Access Compliance Report

Public Rights-of-Way

(Curb Ramps)

Intersection ID: 52518	Main Street: FRANKLIN_MEADOWS_DR	Cross Street: WEDDINGTON_RD	Location: SE
ADA ID: 9E60DA1D1CE2	Ramp Type: Perp	Initial Pass/Fail: Fail	Overall Compliance: No
Severity Score: 12.5			
Codes/Mitigation Info/Possible Solution		Field Measurements/Component Compliance

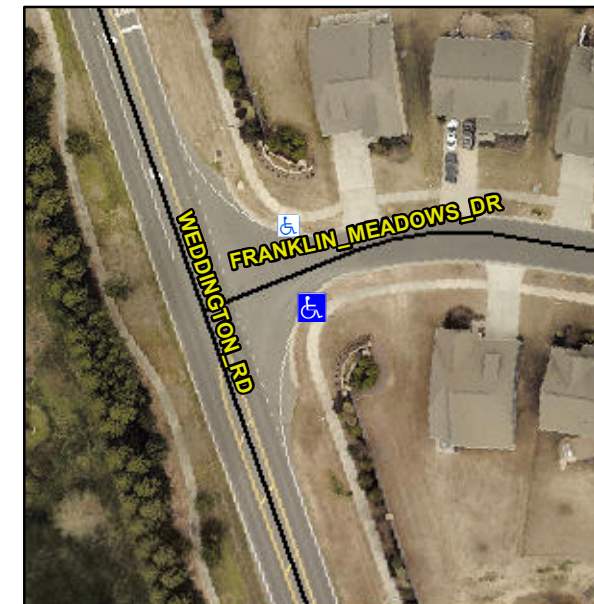
Remove & Replace Entire Ramp.

R304.2.2

Compliance	Description	Data	Compliance	Description	Data
N/A	Ramp Length (in)	67.0	No	Ramp Slope (%)	8.6
Yes	Ramp Width (in)	59.0	Yes	Ramp XSlope (%)	0.1
N/A	Flare Type LT	N/A	N/A	Flare Type RT	N/A
N/A	Flare Slope LT (%)	N/A	N/A	Flare Slope RT (%)	N/A
N/A	Flare Traversable LT?	N/A	N/A	Flare Traversable RT?	N/A
N/A	Landing Length (in)	N/A	N/A	DWS Provided?	N/A
N/A	Landing Width (in)	N/A	N/A	DWS Contrast?	N/A
N/A	Landing Slope (%)	N/A	N/A	DWS Length (in)	N/A
N/A	Landing X Slope (%)	N/A	N/A	DWS Full Width?	N/A
N/A	Landing Curb? (Y/N)	N/A	N/A	DWS Offset (in)	N/A
N/A	Shared Landing?	N/A			
N/A	Gutter Ponding?	N/A	N/A	Gutter Slope (%)	N/A
N/A	Gutter Lip Ht (in)	N/A	N/A	Gutter X Slope (%)	N/A
N/A	Painted X Walk1?	No	N/A	Painted X Walk2?	N/A
	X Walk 1 Direction	To N		X Walk 2 Direction	N/A
N/A	X Walk 1 Width (in)	N/A	N/A	X Walk 2 Width (in)	N/A
	X Walk 1 Slope (%)	0.2		X Walk 2 Slope (%)	N/A
	X Walk 1 X Slope (%)	0.9		X Walk 2 X Slope (%)	N/A
